5 SUB2009-00026

STONE SQUARE PLAZA SUBDIVISION

STONE SQUARE PLAZA SUBDIVISION

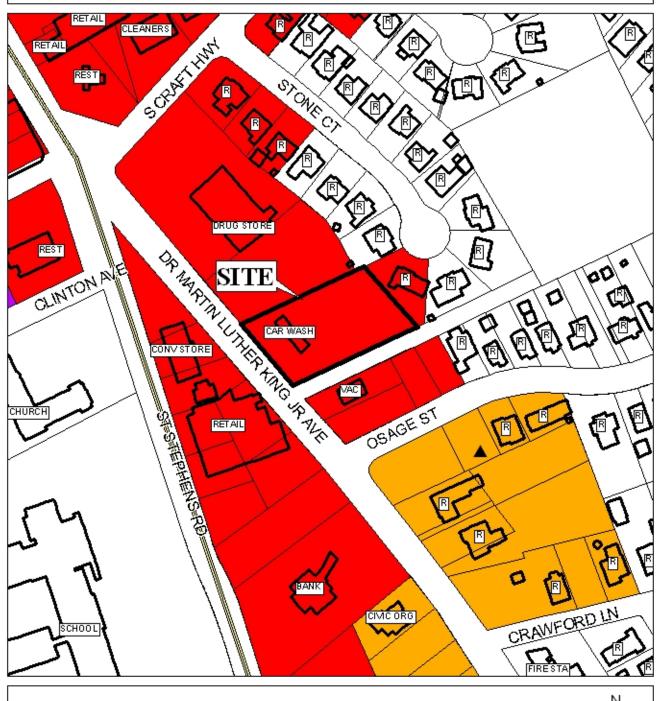
The site fronts Dr. Martin Luther King Jr. Avenue, a minor street with sufficient right-of-way. No right-of-way dedication is required. There also appears to be an unopened right-of-way along the South property line of the site. A note should be placed on the final plat stating that the subdivision is denied access to this right-of-way.

The site has approximately 150' of frontage along Dr. Martin Luther King Jr. Avenue. As a means of access management, a note should be place on the final plat stating that the site is limited to one curb cut to Dr. Martin Luther King Jr. Avenue, with the size, location, and design to be approved by Traffic Engineering and in conformance with AASHTO standards.

The plat meets the minimum size requirement for developments with access to public water and sewer. However, it is requested that the applicant revise the preliminary plat to label the lot with its size in square feet, or provide a table on the plat with the same information.

- 1) placement of a note on the final plat stating that the site is limited to one curb cut, with the size, location, and design to be approved by Traffic Engineering and conform to AASHTO standards;

- 2) placement of a note on the final plat stating that the site is denied access to the unopened right-of-way to the South;
- 3) labeling of the lot with its size in square feet, or the provision of a table on the final plat with the same information;
